ADDENDUM NO. 2
INVITATION FOR BID NO. 141-18
January 10, 2019

This addendum adds, changes, or clarifies the following:

1500 GALLON CONCRETE TREATMENT BOX TOP VIEW

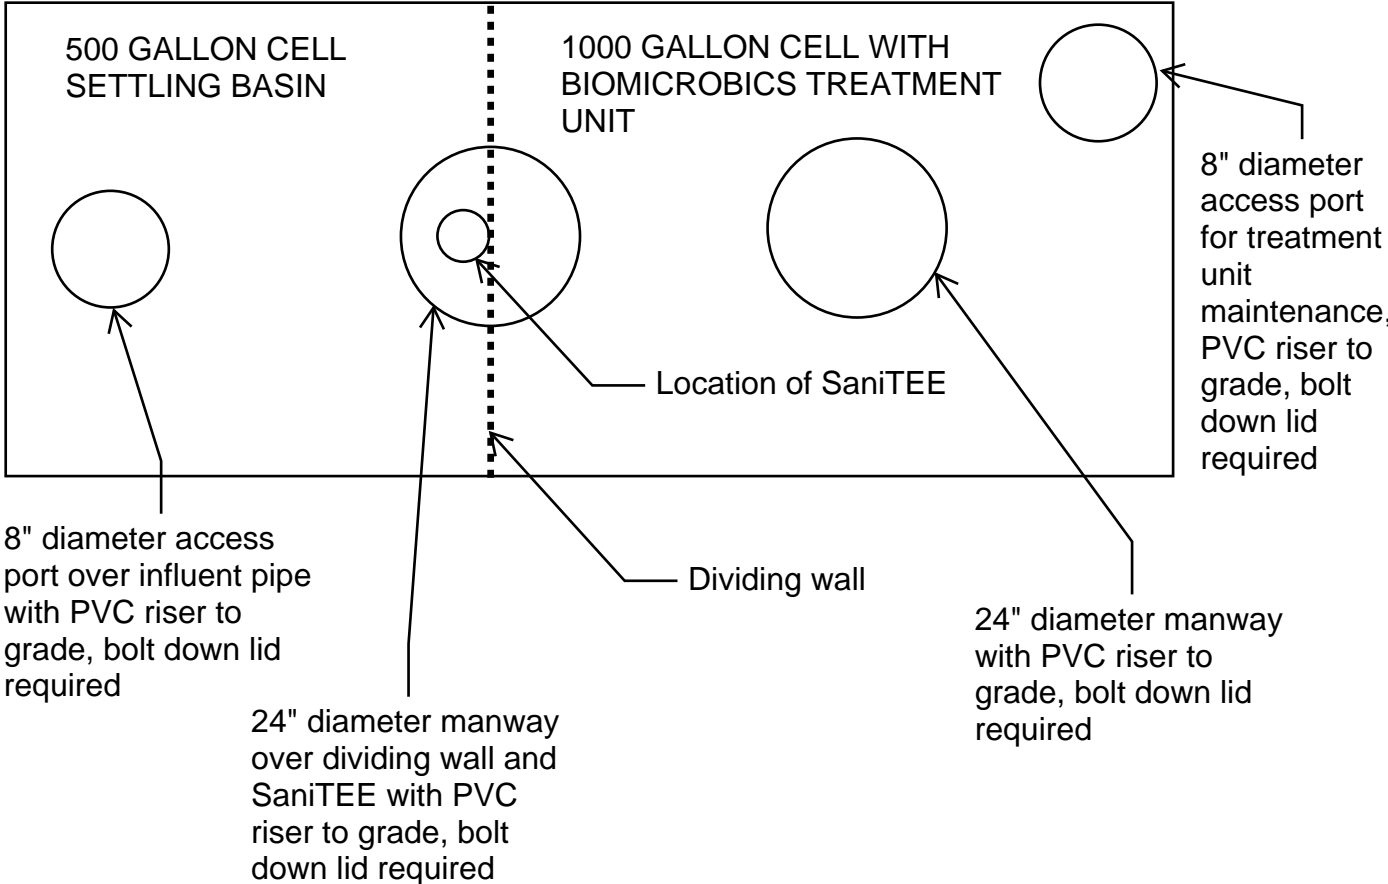
3. ADD 1500 GALLON TREATMENT BOX TOP DETAIL TO TECHNICAL SPECIFICATIONS.
4. REPLACE SHEET 2 OF THE FLOODPLAIN DEVELOPMENT PERMIT WITH THE REVISED SHEET 2 OF THE FLOODPLAIN DEVELOPMENT PERMIT WITH UPDATED SIGNATURE FROM FRANK BRANOM.
5. ADD THE FOLLOWING NOTE TO SHEET 8 OF THE PLAN SET REGARDING THE DISPERSAL FIELD SITE LAYOUT.

ITEM 15 – 1500 GALLON CONCRETE BOX: PAYMENT TO FURNISH AND INSTALL A 1500 GALLON, 2 CELL BOX DIVIDED INTO A 500 GALLON SETTLING BASIN AND A 1000 GALLON TREATMENT CELL BY A CONCRETE DIVIDING WALL. THE BIOMICROBICS MICROFAST 0.625 UNIT SHALL BE INSTALLED IN THE 1000 GALLON CELL. CONCRETE BOX SHALL BE ABLE TO BE INSTALLED IN HIGH GROUNDWATER CONDITIONS. PRICE SHALL INCLUDE CONCRETE BOX INSTALLATION, BACKFILL, AND TESTING.

PRICE SHALL ALSO INCLUDE 2- TWENTY FOUR (24)-INCH DIAMETER MANWAYS, 2-EIGHT (8) INCH DIAMETER ACCESS PORTS, RISERS FOR EACH MANWAY AND ACCESS PORT TO BRING TO GRADE, AND BOLT DOWN COVERS FOR ALL ACCESS PORTS AND MANWAYS. ALL NECESSARY FITTINGS NEEDED TO CONSTRUCT THE ACCESS PORTS AND MANWAYS SHALL BE INCLUDED IN THE PRICE OF THE CONCRETE BOX.
